Before the Hearings Panel at Wellington City Council

In the matter of the Proposed Wellington City District Plan

**Statement of evidence of Alistair Osborne on behalf of Wellington City Council
(Flood Hazard Modelling)**

Figure 1: Current District Plan mapping with modelled flow direction arrows

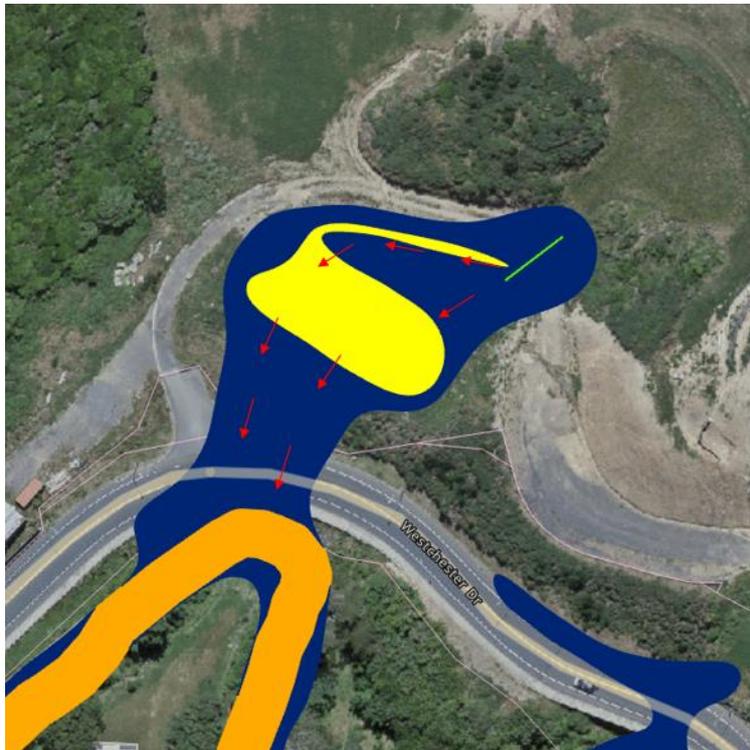
- 18 Rod Halliday considers that the flood ponding and overland flowpath zone at 28 Westchester Drive is inaccurate. His view is that the presence of the Stebbings Dam upstream and concrete retaining wall structures holding up the road will prevent this hazard.

- 19 The modelled flooding predicted to impact 28 Westchester Drive is a result of runoff from the property during the extreme design storm (100-year ARI with allowance for climate changes) rather than overflow from the Porirua Stream. This means it is unaffected by the Stebbings Dam and retaining walls. The modelled stormwater network and topography include a 300mm culvert beneath the access road on the property. Figure 1 shows the modelled culvert in green and indicates the depression where the runoff accumulates before overflowing and flowing across Westchester Drive to the Porirua Stream. The flow direction arrows marked in red, Figure 1. As a result, I do not believe any adjustments should be made to the flood hazard mapping.

Figure 2: Current District Plan mapping

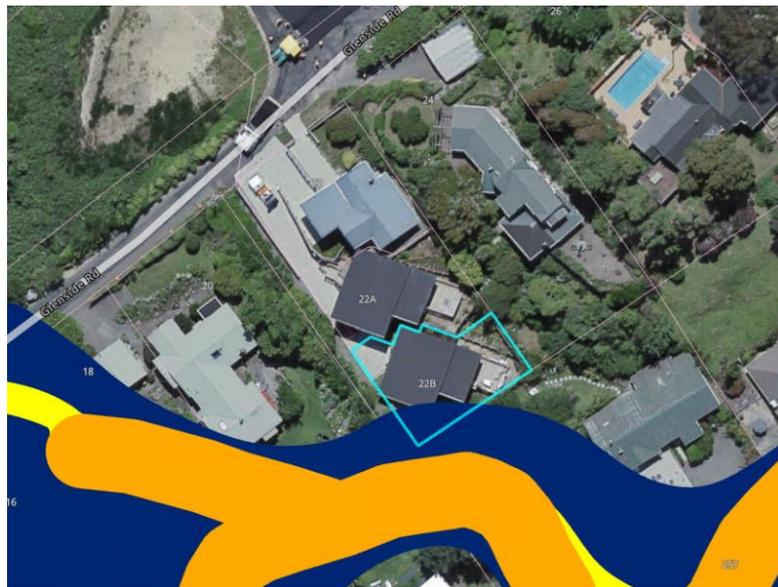
- 20 Oliver Sangster has noted that the property of 22B Glenside Road was filled as part of a recent subdivision for the site and the flood levels do not reflect the new ground levels. The submitter has asked for confirmation whether the flood models consider the new ground level on the site.
- 21 Due to the small nature of the site development and earthworks, the new ground levels have not been captured in the flood model and is not accounted for in the model output. As a result it is recommended that mapping is manually changed, as per Figure 2 and Figure 3, to reflect this.

Figure 6: Modelled Topography (based on 2013 LiDAR)

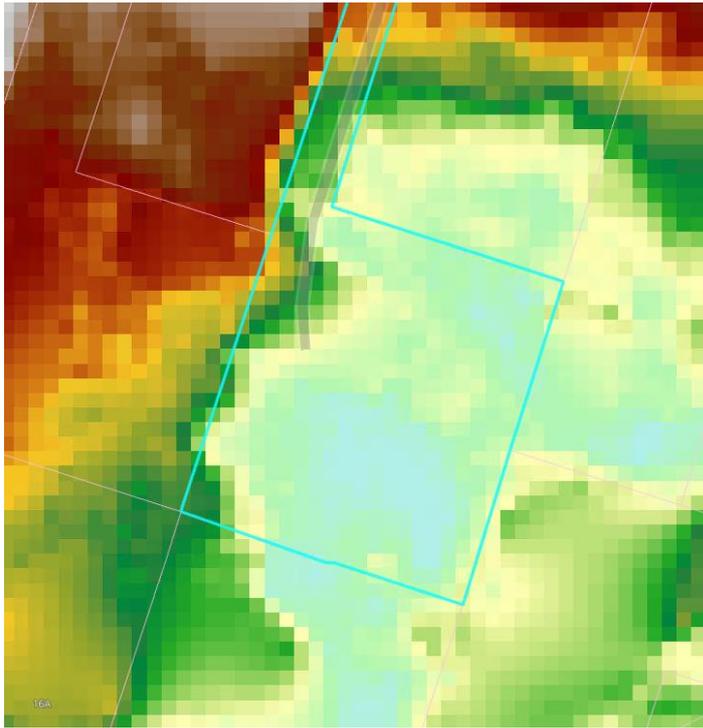
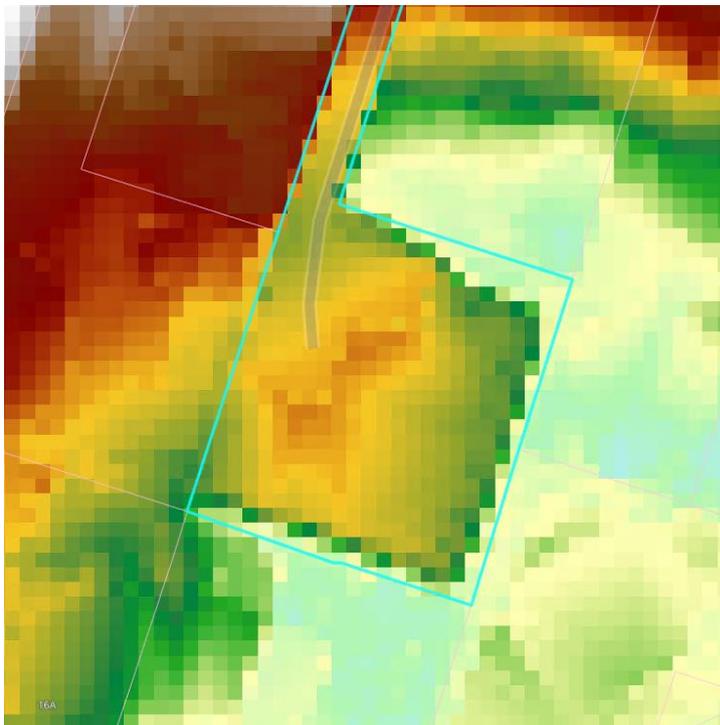
- 26 David Karl has noted that the property at 29a Trent Street was filled by 1m when the new dwelling at this location was built. David would like confirmation whether the flood models take into account the current ground level at the site.
- 27 A comparison of the modelled topography, Figure 6, (based on LiDAR collected in 2013) and new topography, Figure 7, generated from LiDAR collected in 2019/2020 shows the model does not include in the raised building platform at 29a Trent St. This will impact the flood extent in this area. As result, it is recommended that flood hazard map is changed, as per Figure 8 and Figure 9, to reflect this.
